SPB Number: 2023.0301

EXTERIOR UPDATES

Issued: 10/04/2023

STANDARD PLAN BULLETIN NOTICE
RaceTrac Engineering and Construction Division

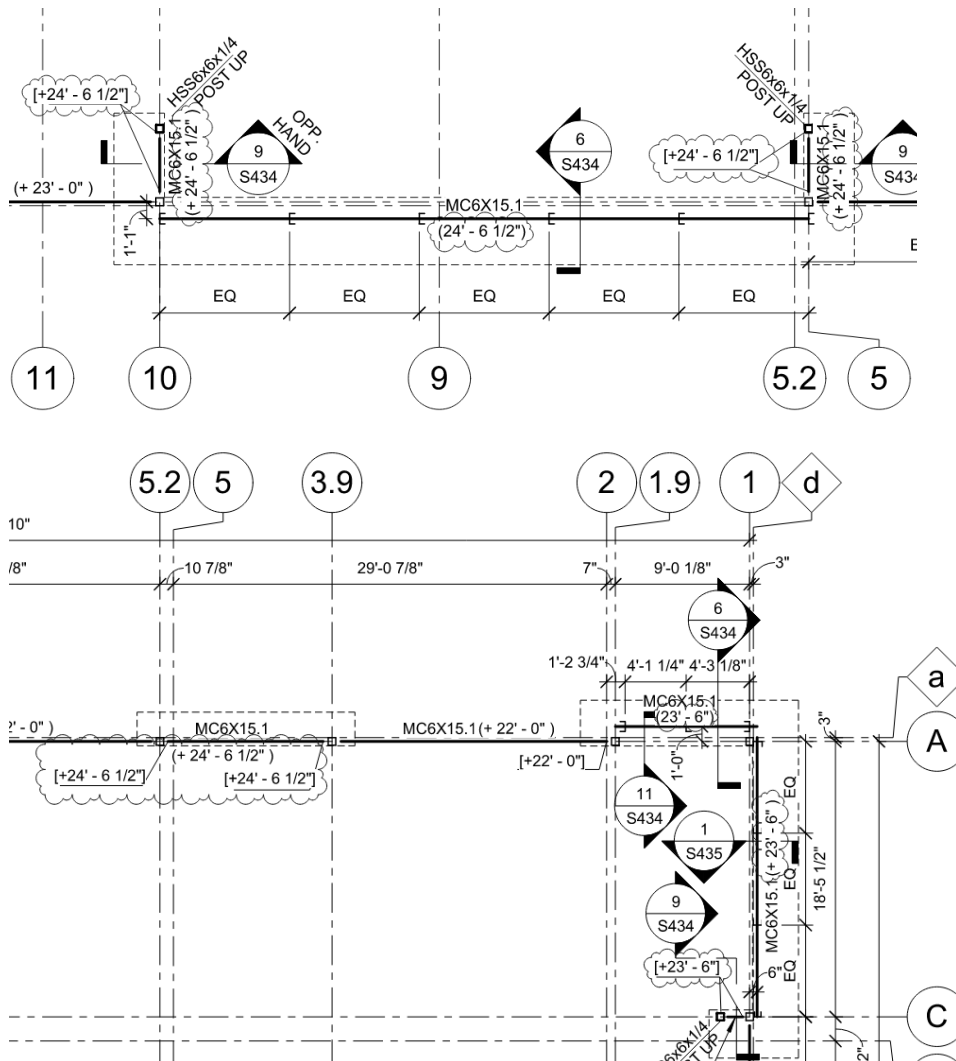
- PARAPET HEIGHT UPDATE:** Lowered the parapet heights at the front and rear entry tower by 4-1/2" and the corner rear tower by 9". Updated the T.O. Steel to say, "See Plan".

- Sheets: A300, A410, A421, A422, A424, A430, S201, S434 & S435
- Attachments: A201

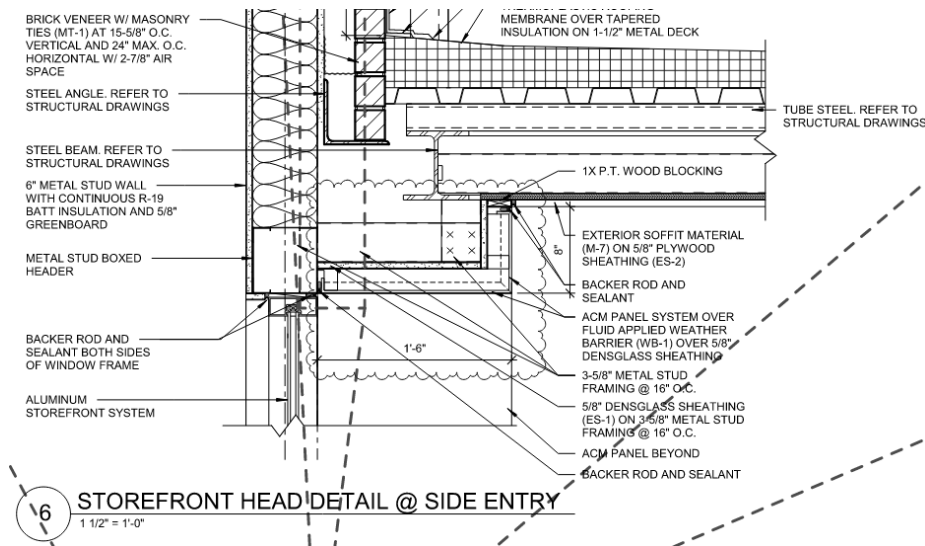
2. **SIDE ENTRY PORTAL:** Reduced the size of the side entry portal depth.

- Sheets: A110, A150, A300, A423, A601, S433 & E150
- Attachments: A601

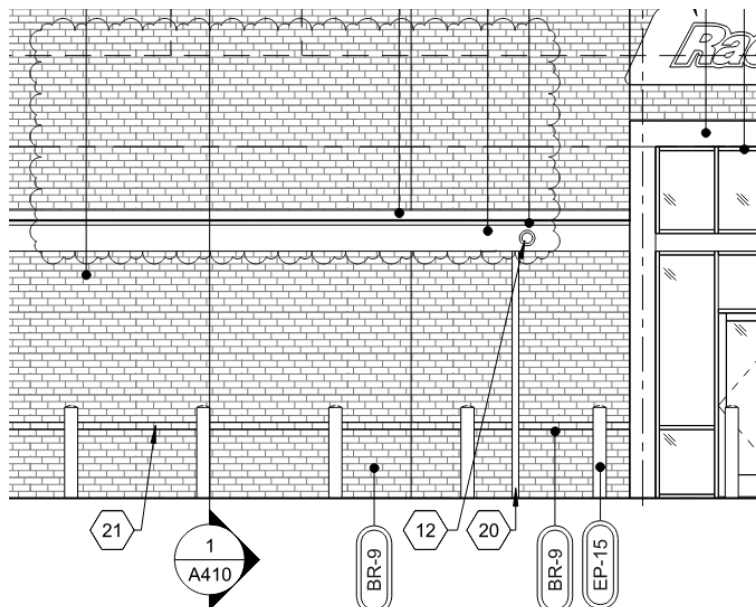
3. **STOREFRONT ABOVE BEVERAGE COOLER:** Removed the storefront above the Beverage Cooler at the front of the building.

- Sheets: A120, A150, A300, A410, A600, A601, S200 & S433
- Attachments: A300

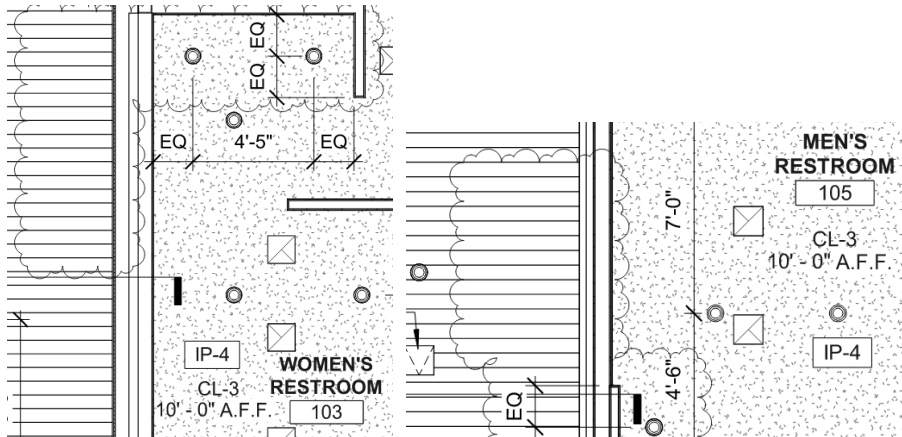
4. **PATIO FANS:** Removed the (2) fans from the patio.

- Sheets: A150, A300, E100, E110, E150 & E430
- Attachments: A150

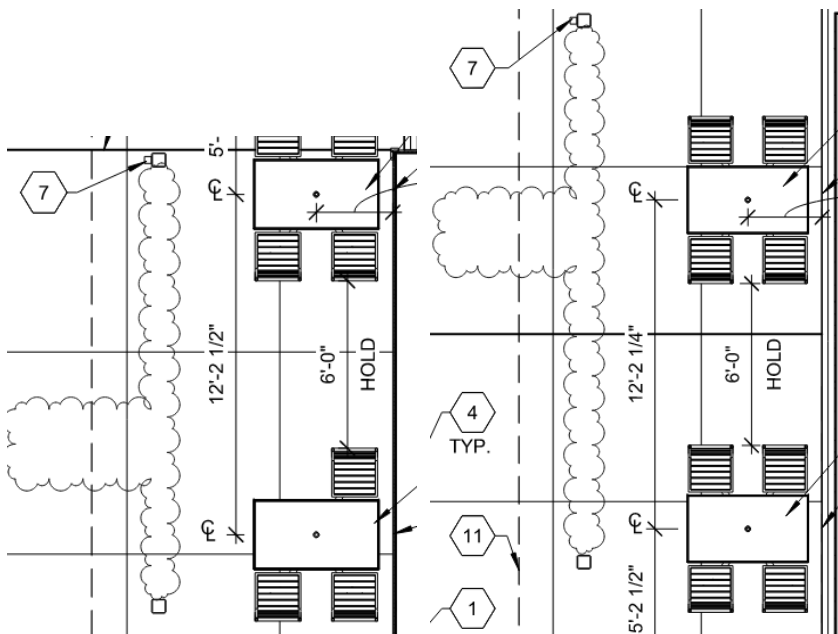
5. **PATIO GUARDRAILS:** Removed the (2) guardrails from the patio.

- Sheets: A100 & A300
- Attachments: A100
